AIRCRAFT, LLC

## SERVICE BULLETIN

**SB-191**

**SUBJECT:** **Rear Seat Belt Attach Bracket**

**Figure 1**

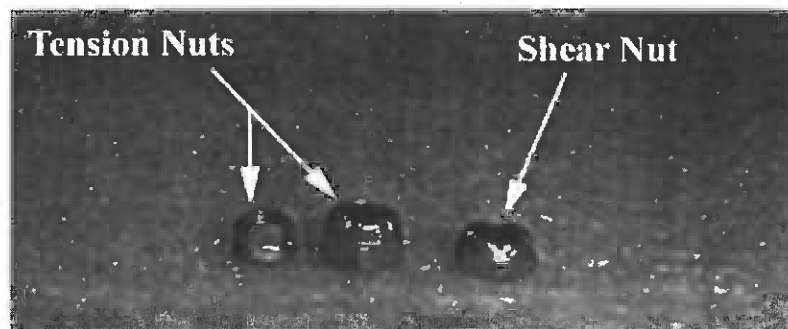
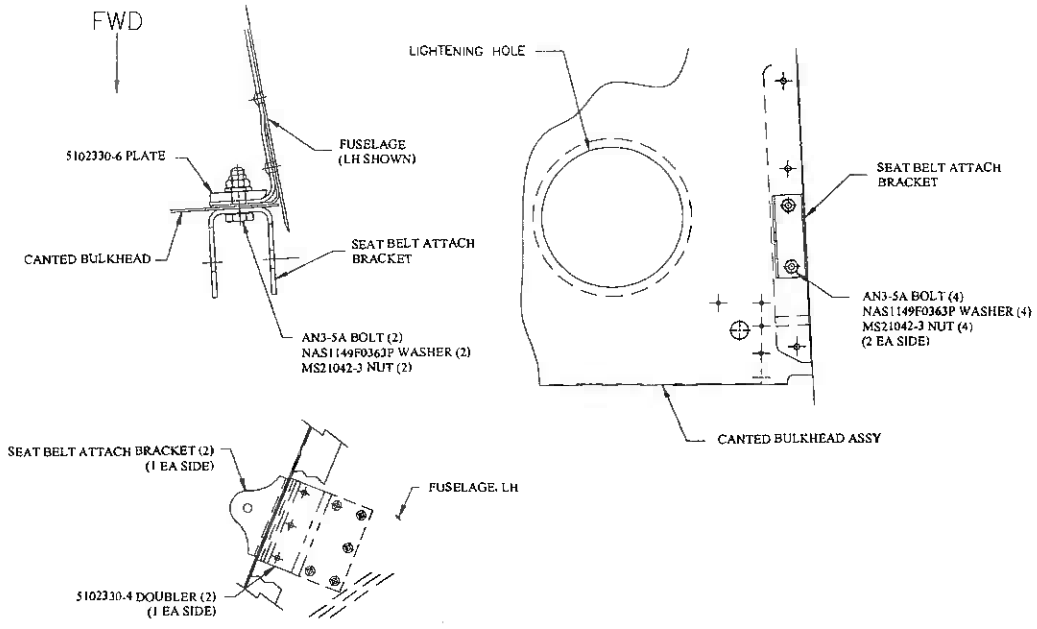
We have received reports of incorrect installation of the outboard rear seat belt attach brackets. In the cases reported, doubler plate P/N 5102330-6 was installed between the seat belt attach bracket and the bulkhead and incorrect nuts were used. This arrangement results in reduced seat belt attachment strength when compared to the approved configuration.

**NOTE: MS20365-1032, MS21044-N3 and MS21042-3 tension nuts are acceptable. Low profile shear nut such as MS20364-1032 or MS21083-N3 are not acceptable. See Figure 1.**

6. If the orientation of the seat belt bracket and -6 plate is not correct and/or incorrect nuts are found, accomplish the following:
  - (a) Remove nuts, washers and two AN3-5A bolts from the seat belt bracket and remove the bracket and -6 plate.
  - (b) Reinstall the bracket and -6 plate as shown in Figure 1. Make sure the -6 plate is positioned with the beveled edge nestled in the corner of the fuselage side panel and the bulkhead.
  - (c) Reattach the seat belt bracket using approved bolts, nuts and washers.
  - (d) Reattach the baggage floor carpet.
  - (e) Flip the rear seat bottom to its original position.
  - (f) Reinstall the rear seat back cushions.
  - (g) Record compliance in the aircraft log book.

**Figure 2**

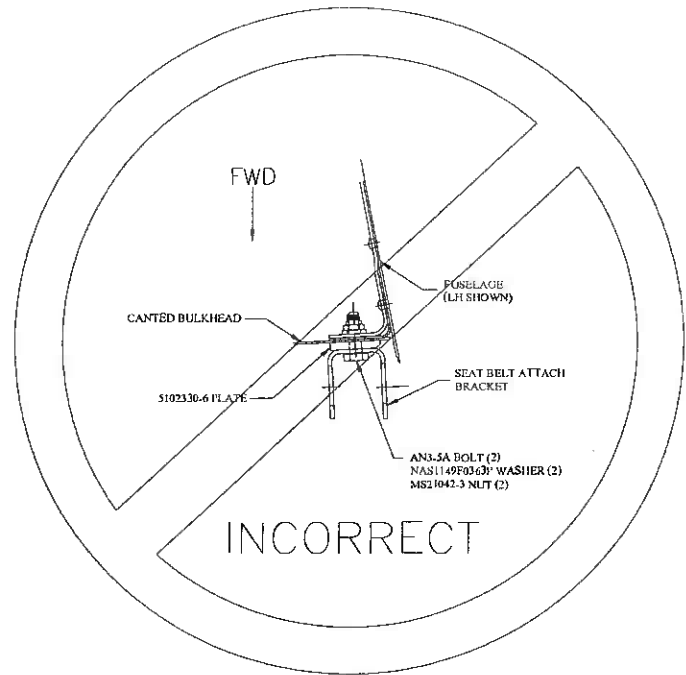
**NOTE: INCORRECT INSTALLATIONS WILL HAVE THE -6 PLATE ON THE FORWARD SIDE OF THE BULKHEAD AND/OR INCORRECT HARDWARE.**
